UNITED STATES ENVIRONMENTAL PROTECTION AGENCY
REGION 4
ATLANTA FEDERAL CENTER
61 FORSYTH STREET
ATLANTA, GEORGIA 30303-8960

The U.S. Environmental Protection Agency has completed review of the document titled, *Technical Memorandum #2, Environmental Management Disposal Facility, Phase 1 Monitoring, Oak Ridge, Tennessee* (DOE/OR/01-2819&D1). This document was generated in support of the proposed Comprehensive Environmental Response, Compensation, and Liability Act (1980, as amended) Environmental Management Disposal Facility (EMDF). A lack of site-specific characterization data for the Central Bear Creek Valley (CBCV) Site 7c location initiated the work conveyed in this document.

**EPA Comments on Technical Memorandum #2, Environmental Management Disposal Facility
Phase 1 Monitoring, Oak Ridge, Tennessee (DOE/OR/01-2819&D1)**

This concept is presented graphically in Figure 8 of the Final EMDF Proposed Plan (08/30/18, p. 12 – see below)

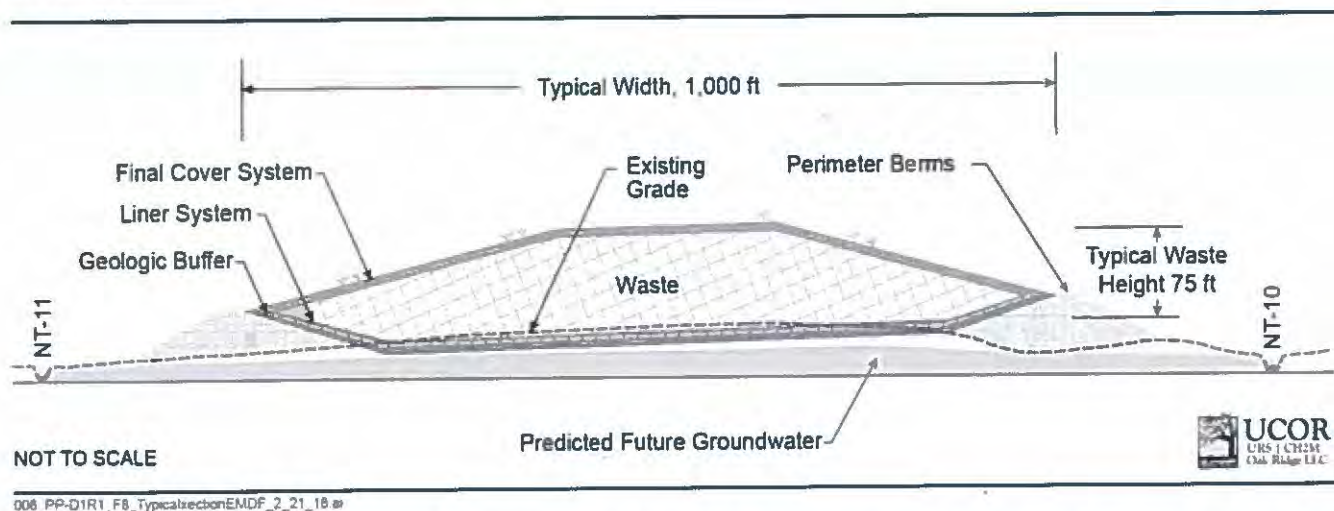
EPA Comment Based on TM#2 groundwater data: The Administrative Record (AR) does not contain documentation that describes how the propose landfill at Site 7c will be protective of elevated groundwater based on the data presented in TM-1 and TM-2. The EMDF Landfill Site Conceptual Model has not been revised and is inaccurate in its portrayal of elevated groundwater. The inaccurate site conceptual model and new elevated groundwater data create issues that cannot be deferred to a post-ROD landfill design document. It must be addressed in the EMDF ROD.

Additionally, to facilitate a decision regarding site suitability for Site 7c, the DOE must be granted an exemption under the state radioactive waste disposal rules and two waivers under the Federal Toxic Substances Control Act (TSCA, 1980). TSCA requires, (1) no hydraulic connection occur between the site and standing or flowing surface water, and (2) the bottom of the landfill liner system or natural in-place soil barrier of a chemical waste landfill shall be at least 50 feet above the historical high-water table (40 CFR 761.75[b][3]).

Regarding (1) above, wetlands occur on both east and west sides of Site 7c with the eastern wetlands extending beneath the proposed waste cell. In reference to (2), the construction of a disposal facility anywhere in Bear Creek Valley would not meet the 50-foot distance requirement. Therefore, the TSCA waiver will be required under that statute for all onsite disposal alternatives. Such a waiver is granted through 40 CFR 761.75(c)(4) by providing "...evidence to the EPA Regional Administrator that operation of the landfill will not present an unreasonable risk of injury to health or the environment from polychlorinated biphenyls (PCBs)..." This information must be included in the ROD.
